FIELD REPORT: Stairs A, E, and G

Project Name.: Motherhouse Senior Housing 605 Stevens Ave. Portland, ME

Date of Inspection August 23, 2018 Page 1 of 9 Report by: David Mele, Architect, Archetype Architects

2 | FIRST FLOOR LIFE SAFETY PLAN
1/16" = 1'-0"

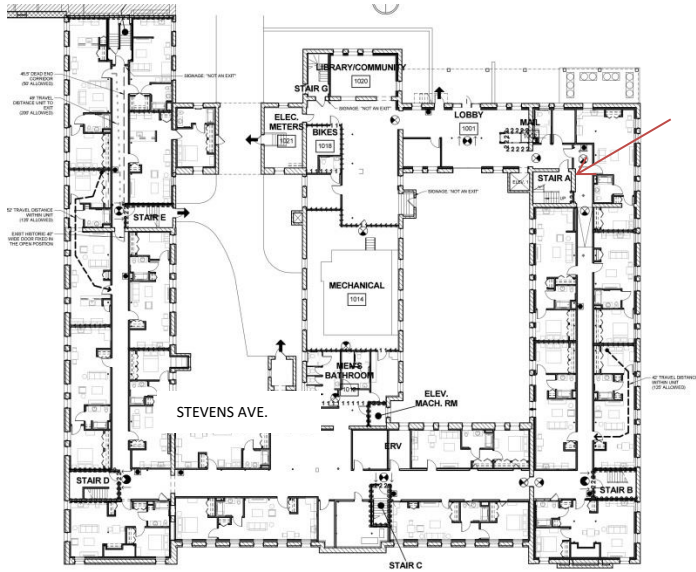
STAIR A – Located near Main Lobby on the east side of the building.

Figure 1: Stair A 1st Floor Discharge Level to Main Lobby – Corridor Side to receive new 90-min. door & frame

Figure 3: Existing Door to be sealed shut and covered w/2 hr. wall

Figure 10

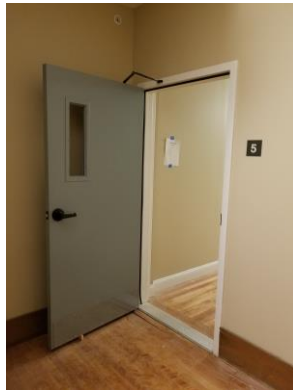
Figure 10: Stair A Level 5 – Corridor side of Vestibule enclosure.

Figure 11: Stair A Level 5 – Vestibule enclosure stairwell side with 90-minute doors in 2-hour rated walls per approved plans.

Figure 12: Stair A Level 5 – Existing Stairwell door inside rated vestibule to remain and permanently held open.

Figure 15

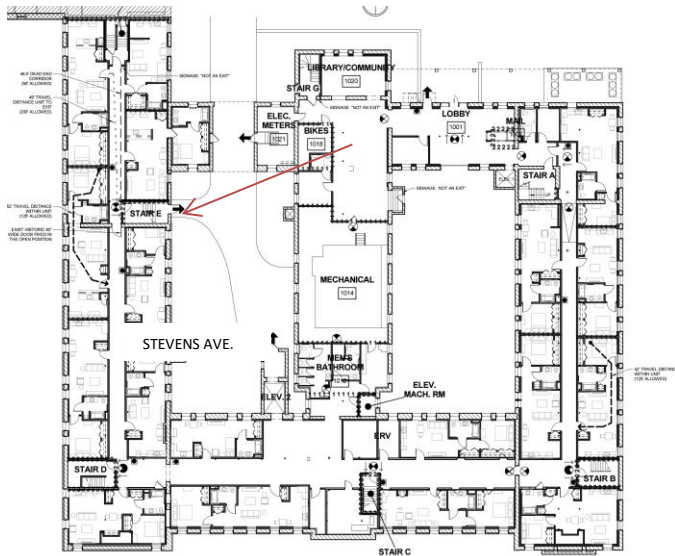
Figure 13: Stair E Level 1 view from north corridor. New 2-hour rated vestibule to receive 90-min. rated door.

Figure 14: Stair E Level 1 View of new 2-hour vestibule from stairwell side.

Figure 15: Stair E Mid-Level – between Level 1 & 2 - Discharge to paved north courtyard. Opening to receive new HM door with weatherstripping and exit hardware.

Figure 22

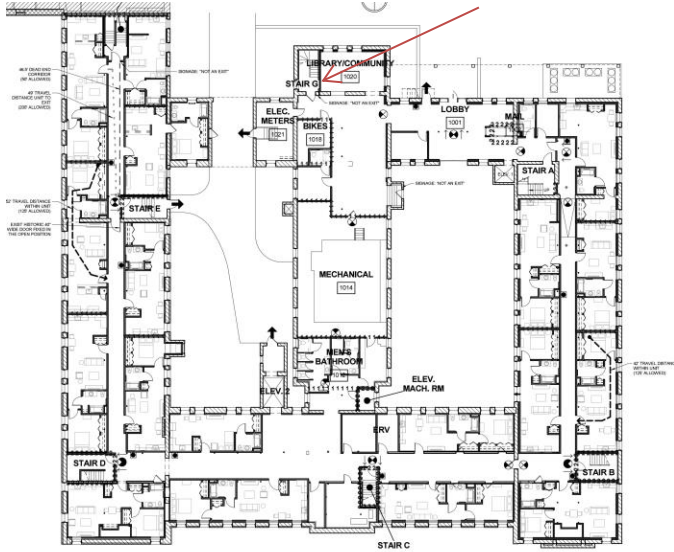
Figure 22: Stair E Level 5 – Corridor Side. At Level 5 a new 2-hour rated enclosure with new 90-minute door has been installed.

1 | SECOND FLOOR LIFE SAFETY PLAN
1/16" = 1'-0"

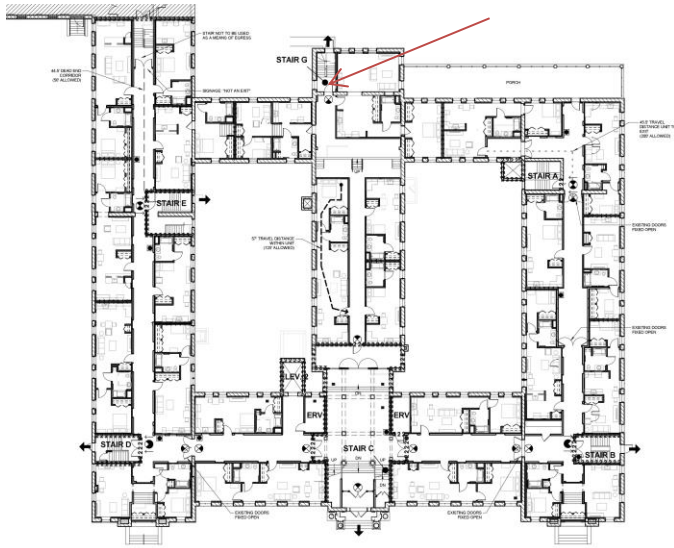
Stair G – Located at the east side of the building, Stair G goes from the 1st Floor to the 3rd Floor at the Chapel. This stairwell is in a masonry enclosure. It also serves as a second means of egress for the apartment units below the Chapel on the 2nd Floor.

1 | THIRD FLOOR LIFE SAFETY PLAN
1/16" = 1'-0"

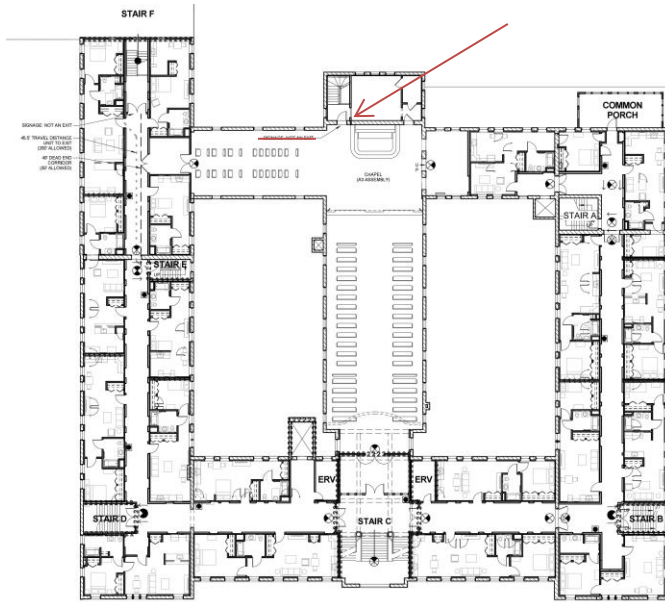
Figures 31 & 32: Stair G Level 3 - Chapel Side

This door will remain in place with the following additional components: new protective metal rails aligned with the stained glass pattern, new hardware, including an exit device, smoke seals, door sweep and threshold. A new lighted exit sign will be installed above the archway.
